<b>Illinois Tollway Standard Drawing Revisions</b>
--

<b>Section C Guardrail &amp; Concrete Barrier</b>		
<b>Standard</b>	<b>Modification Summary</b>	<b>Effective: 03-01-2024</b>
<b>C1-13</b>	<b>GALVANIZED STEEL PLATE BEAM GUARDRAIL</b>

STANDARD C1-13

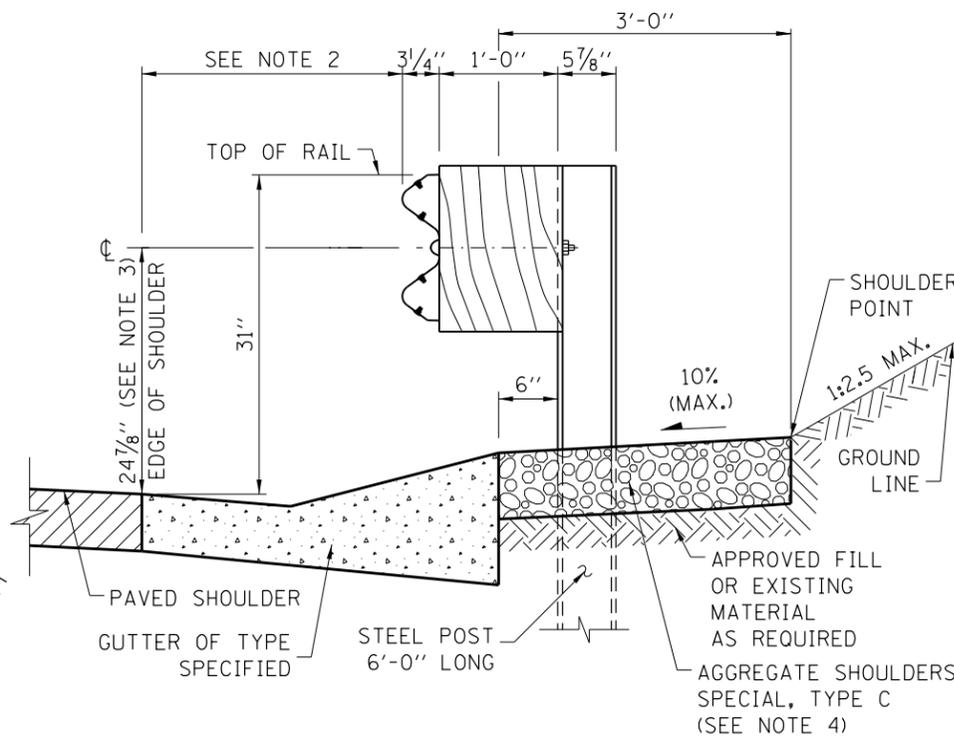
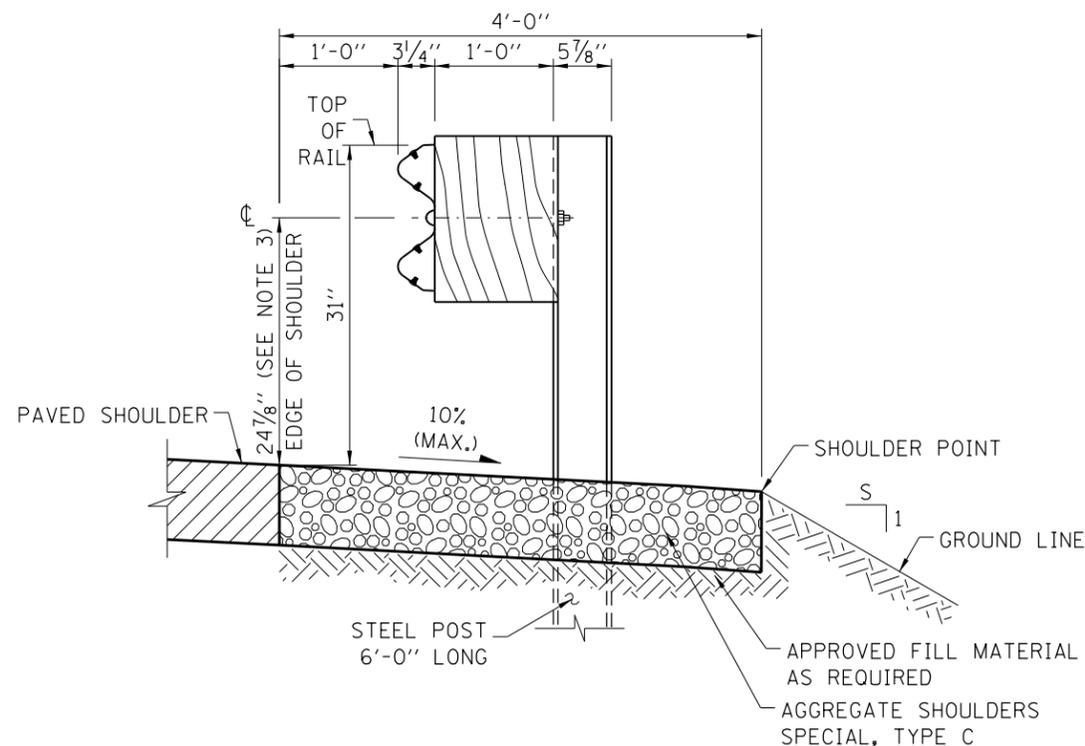
Sheet 1	Removed notes 7 and 10 and their references. Removed requirements for 9' posts.	
Sheet 3	Removed notes relating to 9' post identification.	
<b>C2-01</b>	<b>CONCRETE BARRIER SINGLE FACE, REINFORCED TL-4, L-SHAPE 44 INCH</b>	
	Added note that 1" PJF is to be placed below the barrier base when on top of a drainage structure to note 8.	
<b>C3-11</b>	<b>CONCRETE BARRIER SINGLE FACE, REINFORCED TL-4, 44 INCH</b>	
	Added note that 1" PJF is to be placed below the barrier base when on top of a drainage structure to note 7.	
<b>C4-12</b>	<b>CONCRETE SHOULDER BARRIER TRANSITION, TYPE V-SF</b>	
	Added note citing alignment of NAW with G-2N/3N gutter, on Concrete Shoulder Barrier Transition, V-SF Plan detail, to see Standard B2. Added hot pour joint sealer to Section D-D.	
<b>C15-04</b>	<b>CONCRETE BARRIER SINGLE FACE, REINFORCED TL-5, T-SHAPE 44 INCH</b>	
	Added note that 1" PJF is to be placed below the barrier base when on top of a drainage structure to note 7.

DATE	REVISIONS
3-01-2024	REMOVE 9" POSTS AND REQUIRE FULL WIDTH AGGREGATE SHOULDER
3-01-2021	CHANGED DRAINAGE CONFLICTS TO OMITTED POST, SHEET 4
3-01-2020	MODIFIED NOTE 11 AND HEADING OF TABLE 2B

- WHERE GUTTER IS PROPOSED WITH GUARDRAIL, A 6" MINIMUM THICKNESS OF AGGREGATE SHOULDERS SPECIAL, TYPE C SHALL BE PLACED BEHIND GUTTER. FOR GUARDRAIL WITHOUT GUTTER, AGGREGATE SHOULDER, TYPE C, OF THE SAME THICKNESS AS PAVED SHOULDER SLOPING AWAY TO A 6" MIN. THICKNESS.

STANDARD C2-01

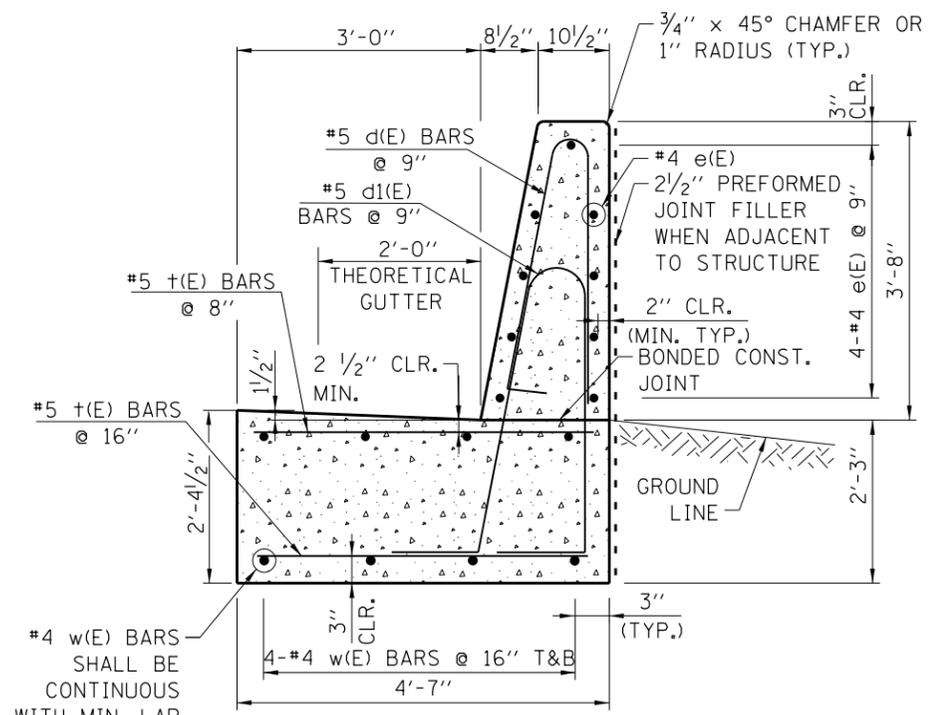
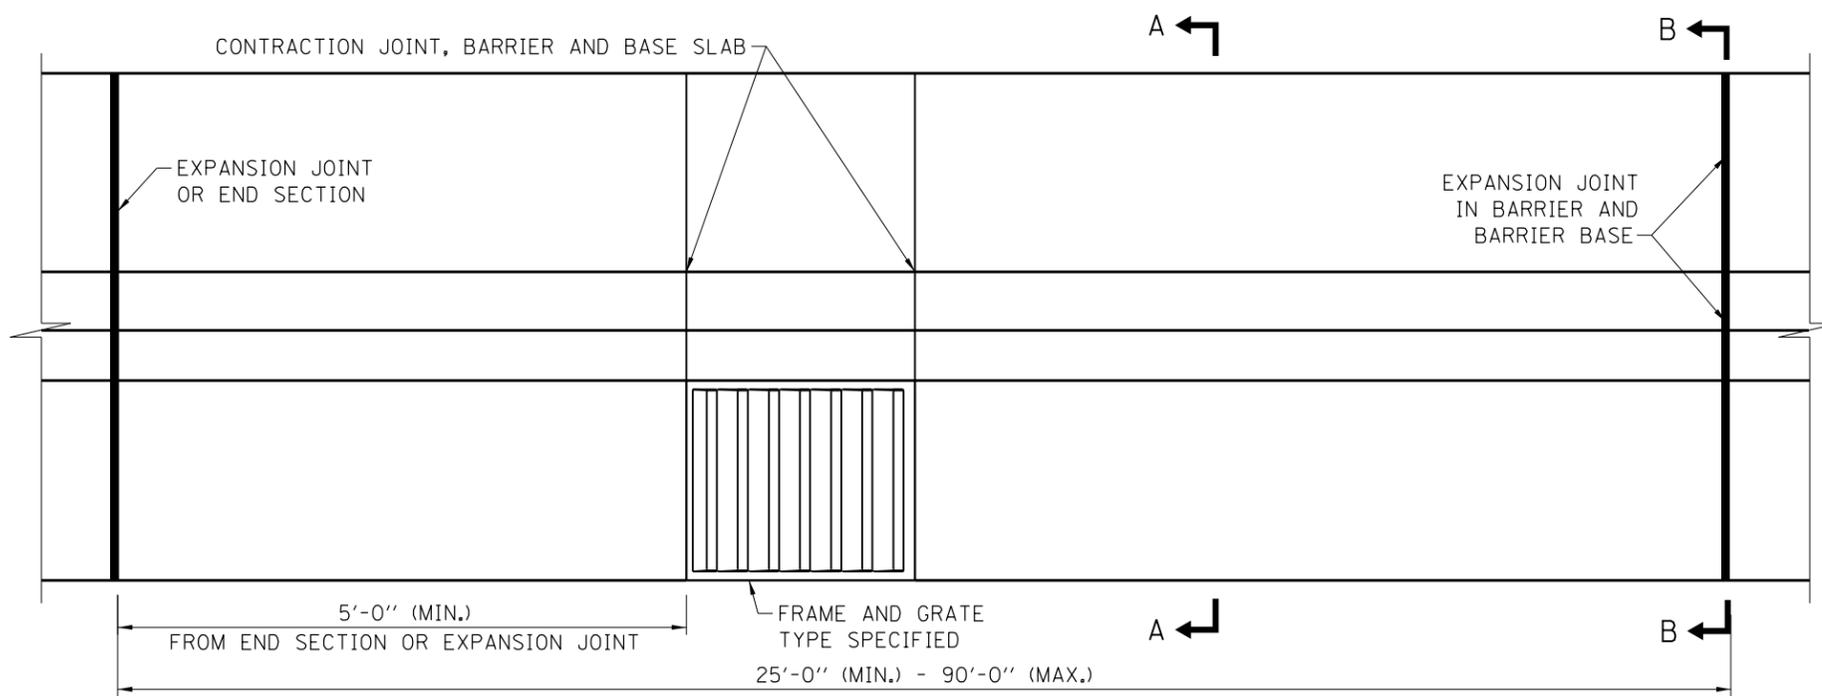
DATE	REVISIONS
3-01-2024	ADDED PJF BETWEEN BASE AND DRAINAGE STRUCTURE

8. AT DRAINAGE STRUCTURES, CUT FOOTING BARS TO FIT. ADD ADDITIONAL +, +1, AND +2 BARS ON EACH SIDE OF THE DRAINAGE STRUCTURE. A 1" PJF SHALL BE PLACED BELOW THE BARRIER BASE WHEN IT SITS UPON A FLAT SLAB DRAINAGE STRUCTURE.

STANDARD C3-11

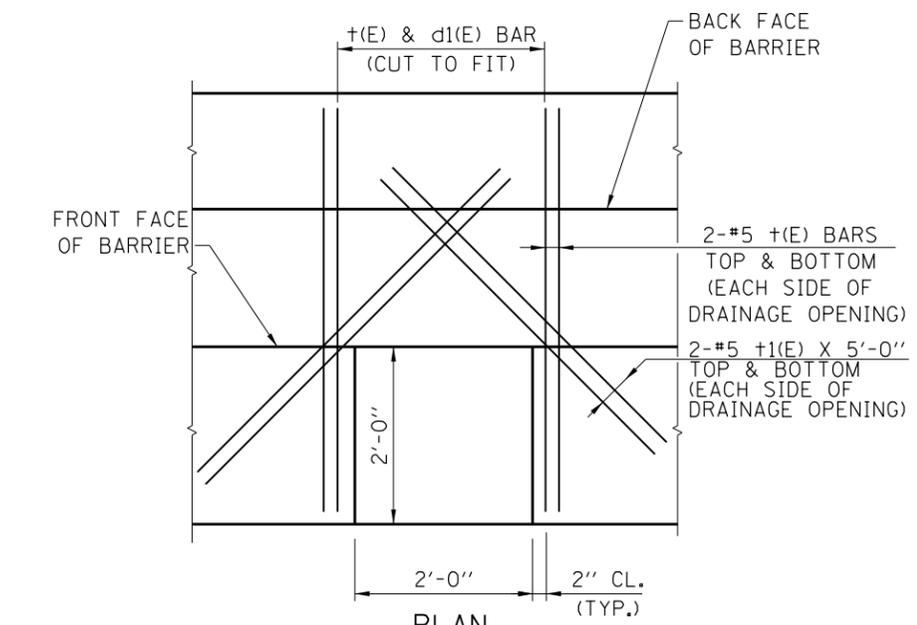
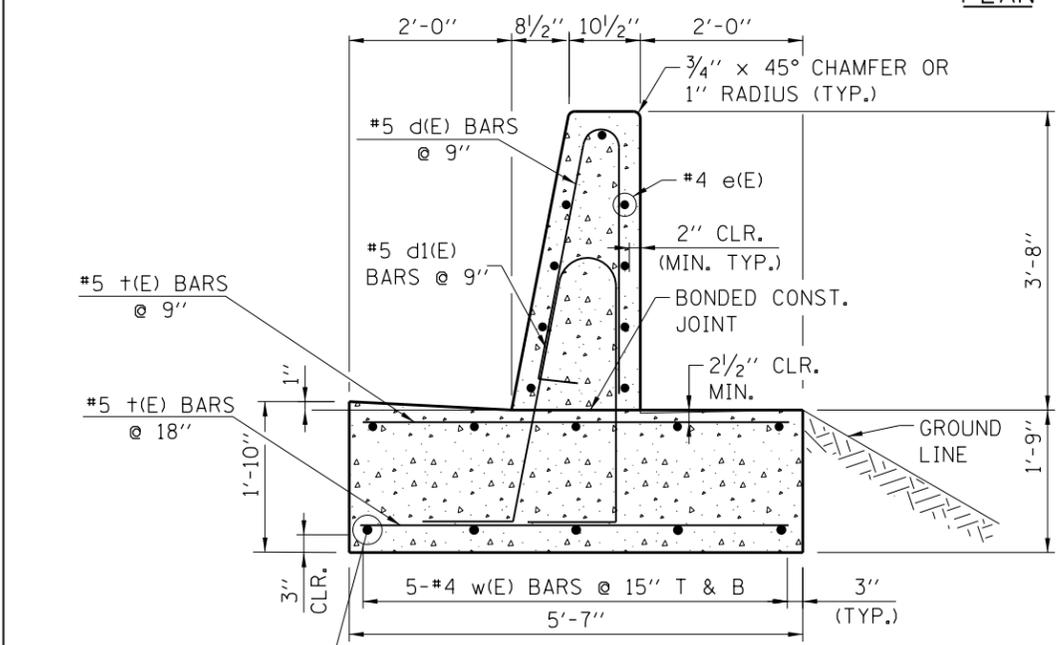
DATE	REVISIONS
3-01-2024	ADDED PJF BETWEEN BASE AND DRAINAGE STRUCTURE
3-01-2023	REVISED REINF. AT DRAINAGE STR.
3-01-2022	REVISED CALLOUTS AND NOTES
3-01-2020	REVISED TO 44" HEIGHT & RENAMED
3-01-2019	REVISED TO CONSTANT SLOPE

7. AT DRAINAGE STRUCTURES, CUT FOOTING BARS TO FIT. ADD ADDITIONAL + AND +1 BARS ON EACH SIDE OF THE DRAINAGE STRUCTURE. A 1" PJF SHALL BE PLACED BELOW THE BARRIER BASE WHEN IT SITS UPON A FLAT SLAB DRAINAGE STRUCTURE.

STANDARD C16-04

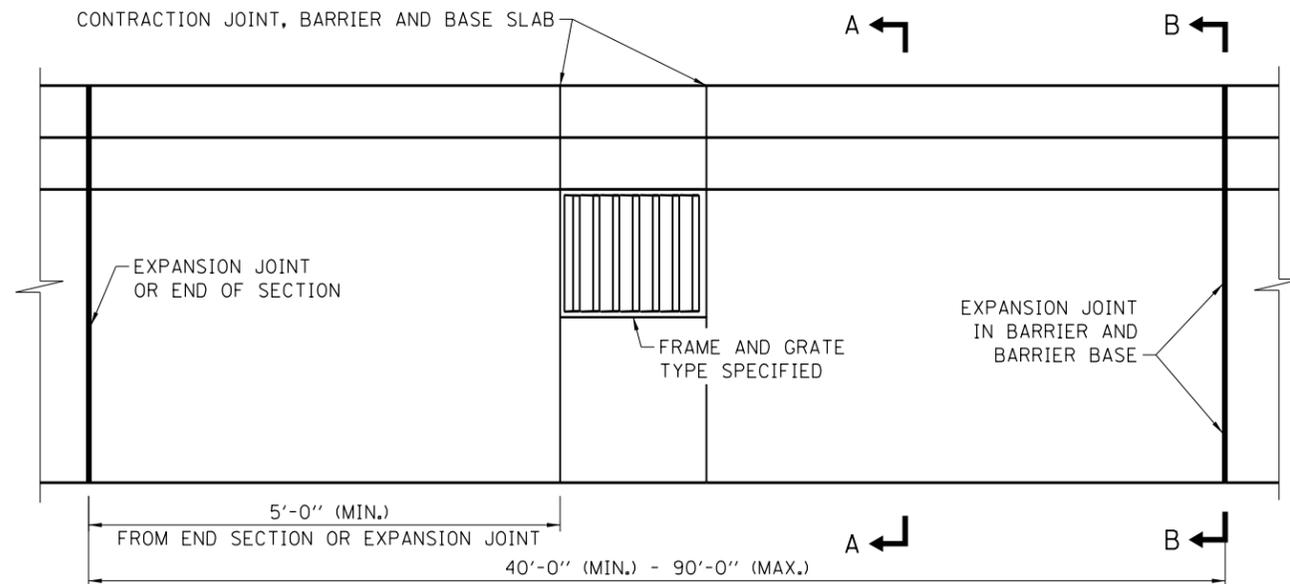
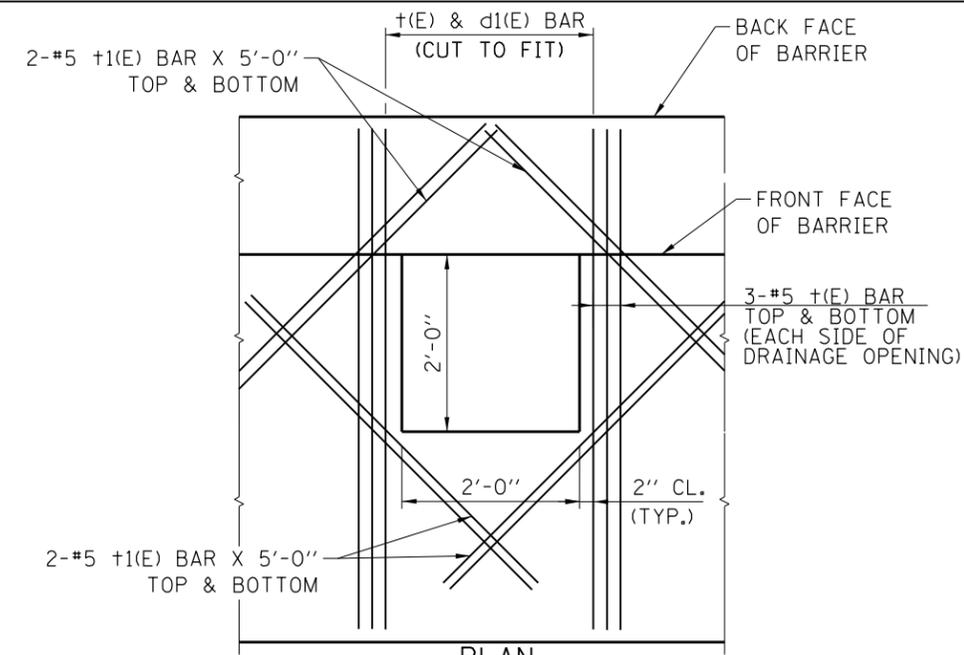
<b>C16-04</b>	<b>CONCRETE BARRIER SINGLE FACE, REINFORCED TL-5, L-SHAPE 44 INCH</b>	
	Added note that 1" PJF is to be placed below the barrier base when on top of a drainage structure to note 7.	
<b>C17-05</b>	<b>CONCRETE BARRIER SINGLE FACE, REINFORCED TL-5, 54 INCH</b>	
	Added note that 1" PJF is to be placed below the barrier base when on top of a drainage structure to note 7.

DATE	REVISIONS
3-01-2024	ADDED PJF BETWEEN BASE AND DRAINAGE STRUCTURES
3-01-2023	REVISED NOTE #1 AND REINF. DETAIL AT DRAINAGE STRUCTURES
3-01-2022	REVISED NOTES & CALLOUTS

- AT DRAINAGE STRUCTURES, CUT FOOTING BARS TO FIT. ADD ADDITIONAL + AND +1 BARS ON EACH SIDE OF THE DRAINAGE STRUCTURE. A 1" PJF SHALL BE PLACED BELOW THE BARRIER BASE WHEN IT SITS UPON A FLAT SLAB DRAINAGE STRUCTURE.

STANDARD C17-05

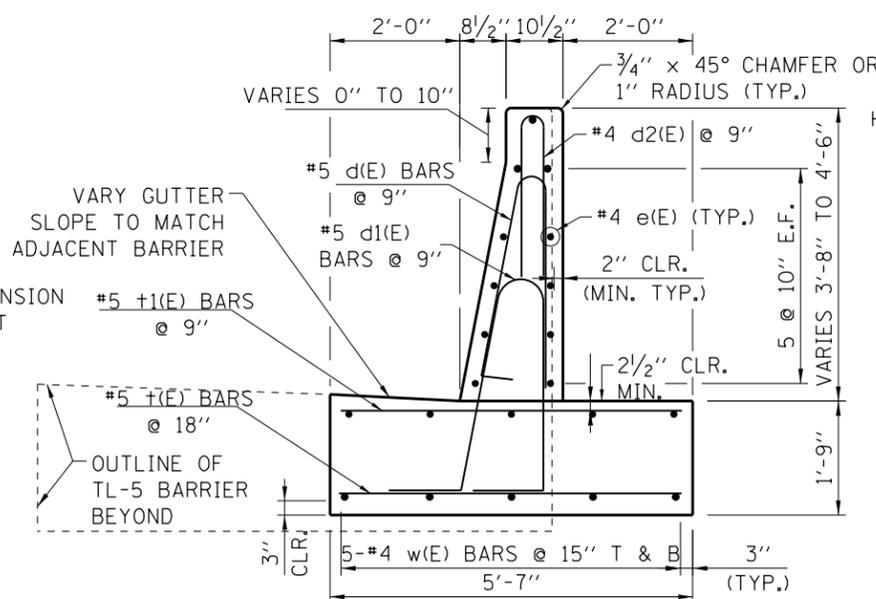
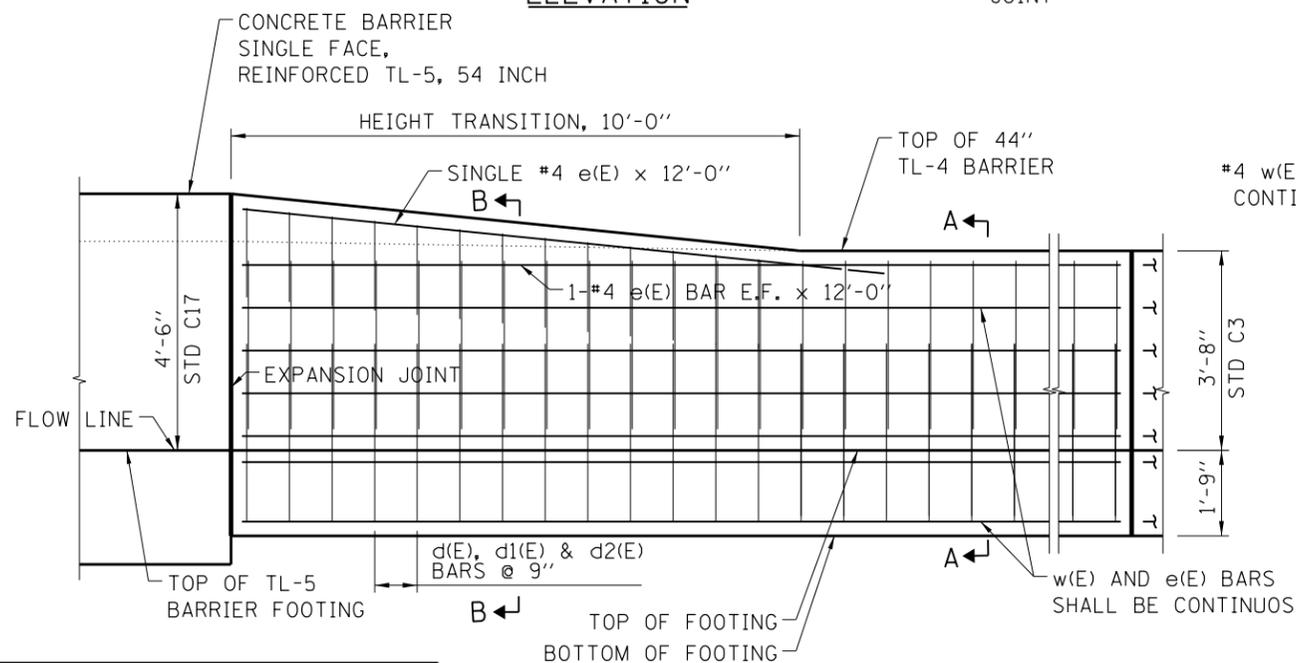
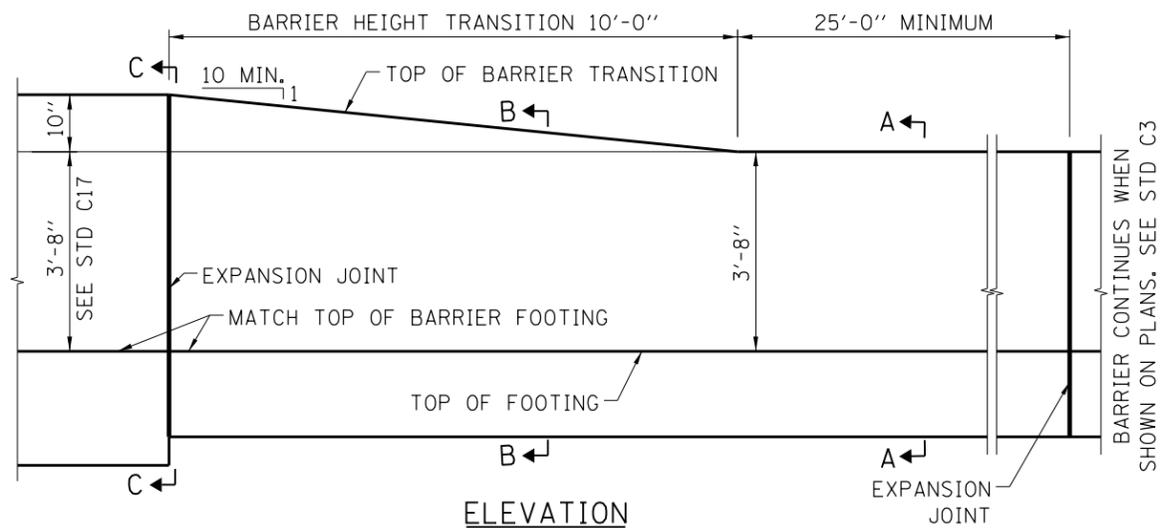
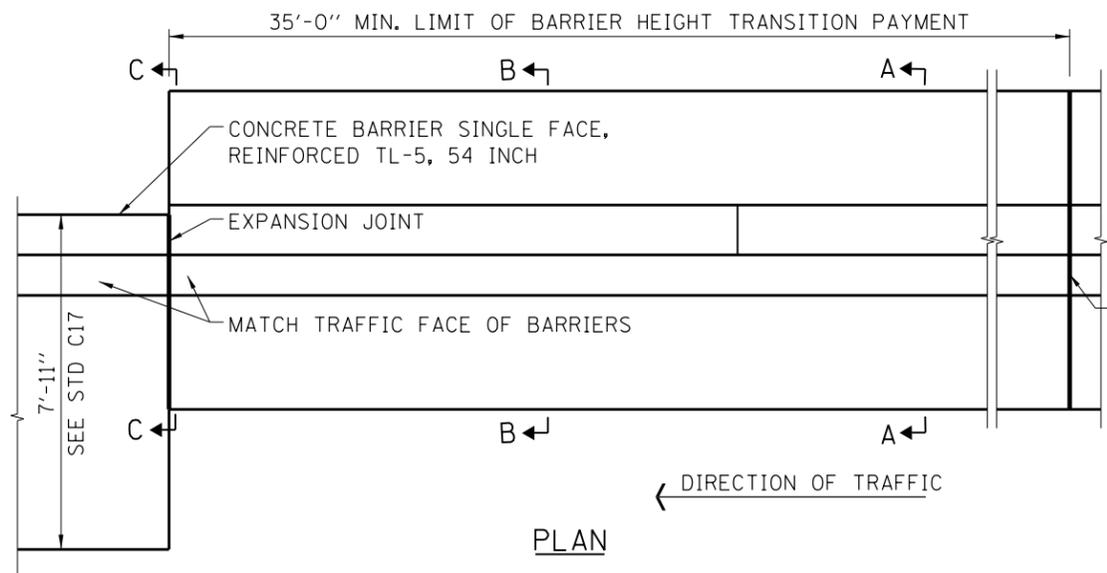
DATE	REVISIONS
3-01-2024	ADDED PJF BETWEEN BASE AND DRAINAGE STRUCTURE
3-01-2023	REVISED REINF. DETAIL AT DRN. STRUCTURE. REMOVED NOTE 9
3-01-2022	REVISED NOTE 4.
3-01-2021	REVISED REBAR LENGTH, ADDED NOTE

7. AT DRAINAGE STRUCTURES, CUT FOOTING BARS TO FIT. ADD ADDITIONAL +, AND +1 BARS ON EACH SIDE OF THE DRAINAGE STRUCTURE. A 1" PJF SHALL BE PLACED BELOW THE BARRIER BASE WHEN IT SITS UPON A FLAT SLAB DRAINAGE STRUCTURE.
